Overview: Production error; immobilizer wire (orange/black) in pin position #4 instead of pin position #5. Although an effort to correct the issue was made, some quantity of harnesses did get shipped before the issue was spotted. We are advising to inspect the harness BLADE connector before attempting to install the harness and program the module.

Overview: The FTI-STP1 harness may require modification for use in **automatic transmission (AT)** applications, some of the product was able to be modified before release, but a small quantity was released before being able to be modified internally.

FTI-STP1: Vehicle Coverage and Preparation Notes

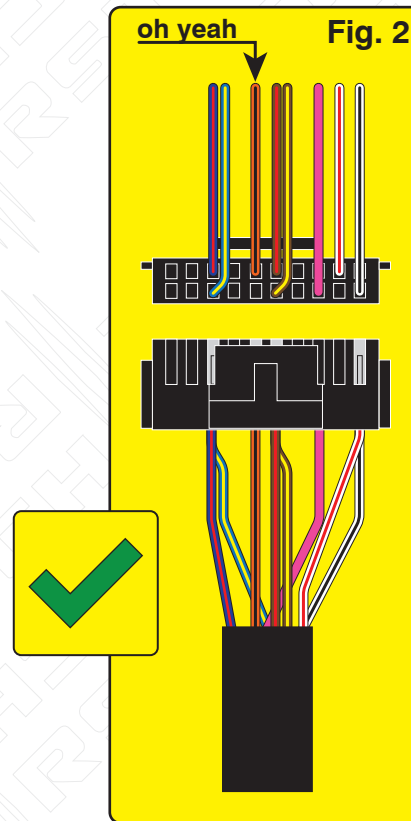
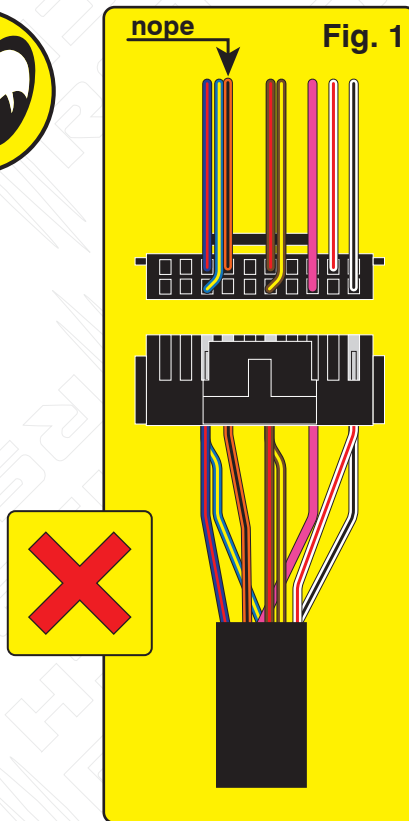
Issue: Module fails to program to vehicle, will not allow the vehicle to be remote started.

Correction: Step 1.) Locate the orange/black wire and confirm whether it is positioned as illustrated in Fig. 1 or Fig. 2. If the wire is as illustrated in Fig.1, proceed with Step 2 through 5 and complete the repair procedure outlined, if the wire is as illustrated in Fig. 2, correction is not necessary, proceed with harness installation and module programming.

Step 2.) Using a pick, lightly depress the catch that secures the terminal in the housing then remove the wire and terminal from the housing.

Step 3.) Using a fine tip razor or utility knife, insert the blade beneath the terminal catch and raise it slightly, so that it can be reused to secure the terminal when reinserted into the BLADE connector housing.

Step 4.) Refer to Fig. 2 for correct position of the orange/black wire (next to brown/red) then reinsert the terminal, pressing lightly until the catch 'snaps' into place, securing the terminal in the connector housing.

Step 5.) The repair is complete, proceed with installation and programming.

MODIFICATION REQUIRED FOR AUTOMATIC TRANSMISSION APPLICATIONS ONLY

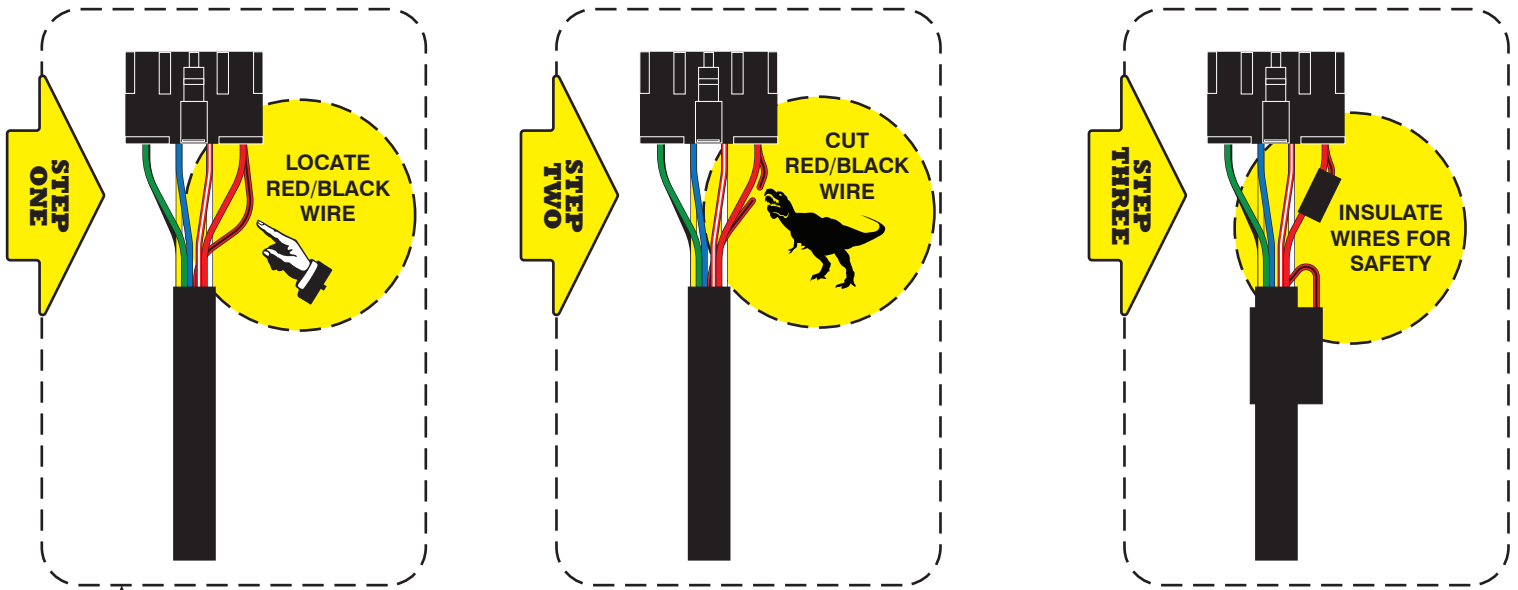
Issue: The FTI-STP1 T-harness has been designed to be compatible with AT (automatic transmission) & MT (manual transmission) applications, but due to a production oversight, the selection mechanism was defaulted to MT mode.

Using a harness configured for an MT application, in an AT equipped vehicle, could result in vehicle module damage, it is advised that the harness be returned to AT mode before installation in vehicles equipped with an automatic transmission.

Correction: Locate the **red/black (+ Clutch)** wire provided in the CN1 connector of the main harness assembly. Cut the **red/black** wire, either flush to the CN1 connector, or leaving enough wire exposed so that you can insulate and secure the ends of the wire that remain after cutting. Insulate each of the remaining ends of the **red/black** wire and secure to prevent any possibility of a short circuit.

If the red/black wire already been disconnected, no further modification is required for AT equipped vehicles.
